Received Tuesday February 2, 2016 via Ir Hans Roest from SodM

Main questions from Prof. Hou to NAM about the water injection studies

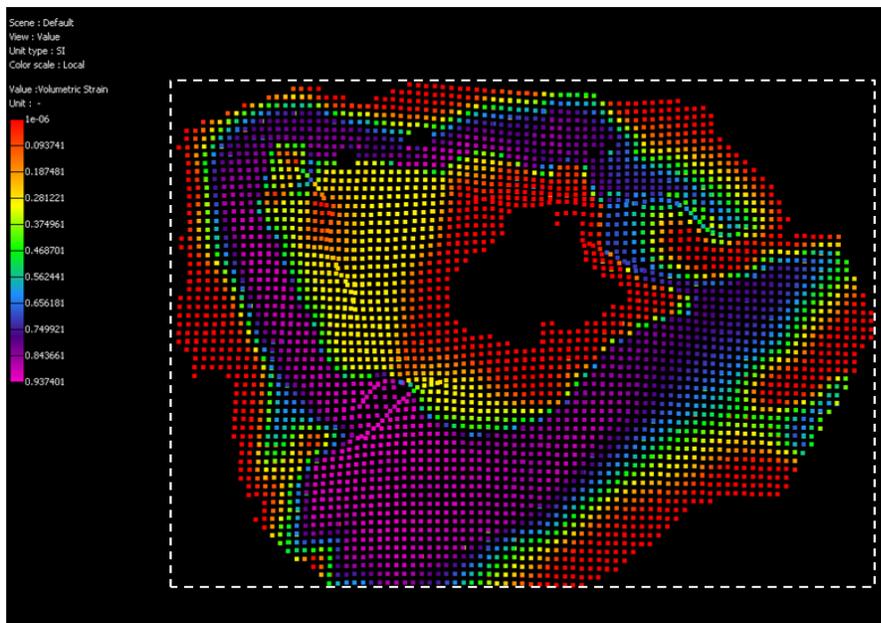
- According to the reviewer, the maximum subsidence in the center could finally be larger than 14 cm. With very conservative assumptions the maximum could be 0.26 m (long term). NAM should clarify the x- and y- axis of figures 3.2, 3.3, 3.4, 3.5 and 3.6 to show the influence area at the surface. Remark: the subsidence rate will be very small.

Below are the noted figures with the outlines of the modeled areas indicated (Fig 3.2 and 3.3 cover a smaller area than Fig 3.4 to 6). As expected, the subsidence area is clearly wider than the area where the shrinkage at reservoir level takes place (see Fig. 3.4 below).

We do not recognize the 26 cm surface subsidence. We recognize that in our models the worst case vertical displacement at top Zechstein is about 24 cm but this translates to a maximum surface subsidence of 14 cm. This worst case is derived from the concentrated dissolution case which assumes that all water is concentrated in a small part of the field rather than (what is expected) migrates and distributes over all flanks of the field with an accumulation of gas building up in the crest. Please also note that the total volume of salt that can be dissolved is finite, because it is limited by the dissolution capacity of the finite volume of water that is injected. Also it is assumed that the injected water can become completely salt saturated which is a highly conservative estimate given that even after many millions of years the original aquifer water in the reservoir is not fully saturated. In addition it is assumed that salt dissolution will only take place from the interface with the overlying cap salt only. This is again a conservative estimate given that some salts will be dissolved from the lower salt layers and some water will not have direct access to salt (for instance by the remaining gas cap).
